Access Compliance Report Public Rights-of-Way (Curb Ramps)

Main Street: ARRIATE_ST		Cross Street: GRANJA_CT		Location:	SE
ADA ID: RPRK211119135459	Ramp Type: Type 4 - Parallel	Initial Pass/Fail: Fail	Overall Compliance: No	Severity Score:	15
Codes/Mitigation Info/Possible Solution			Field Measurements/Component Compliance

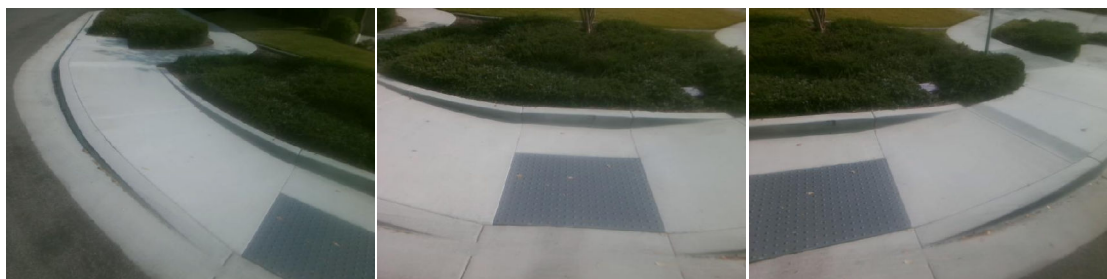
Compliance	Description	Data	Compliance	Description	Data
N/A	Ramp Length LT (in)	84	N/A	Ramp Length RT (in)	64
Yes	Ramp Width LT (in)	60	Yes	Ramp Width RT (in)	60
No	Ramp Run Slope LT (%)	9.4	Yes	Ramp Run Slope RT (%)	4.9
Yes	Ramp Cross Slope LT (%)	1.2	Yes	Ramp Cross Slope RT (%)	0.6
N/A	Landing Present	N/A	N/A	DWS Provided	N/A
N/A	Landing Length (in)	N/A	N/A	DWS Contrast	N/A
N/A	Landing Width (in)	N/A	N/A	DWS Length (in)	N/A
N/A	Landing Run Slope (%)	N/A	N/A	DWS Full Width	N/A
N/A	Landing Cross Slope (%)	N/A		DWS Offset Type	N/A
N/A	Landing Movement Obstructed?	N/A	N/A	DWS Offset Left (in)	N/A
	Landing Movement Type	N/A	N/A	DWS Offset Right (in)	N/A
N/A	Landing Shared	N/A			
N/A	Clear Space	Yes			
N/A	Clear Space To Crosswalk (in)	N/A			
N/A	Marked Crosswalk 1	No	N/A	Marked Crosswalk 2	No
	Crossing 1 Direction	N		Crossing 2 Direction	W
	Marked Crosswalk 1 Width (in)	N/A		Marked Crosswalk 2 Width (in)	N/A

Remove & Replace Curb Ramp With Two New Directional Ramps or Equivalent.

R304.3.2, STD 1115
